1200801 EXCAVATION AND EMBANKMENT
COMMENTS FROM INTERNAL/INDUSTRY REVIEW

The 2014 Design Standard 500, page 1 of 2.

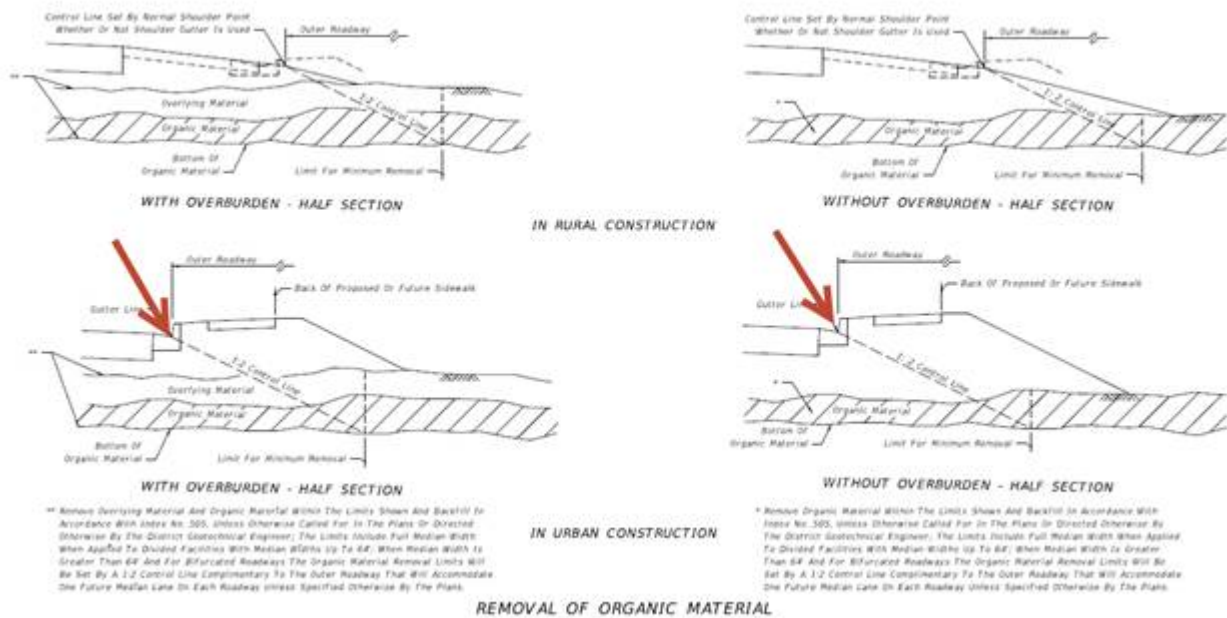
Please note the point where the control line starts, with reference to curb and the text that is used to describe the line in
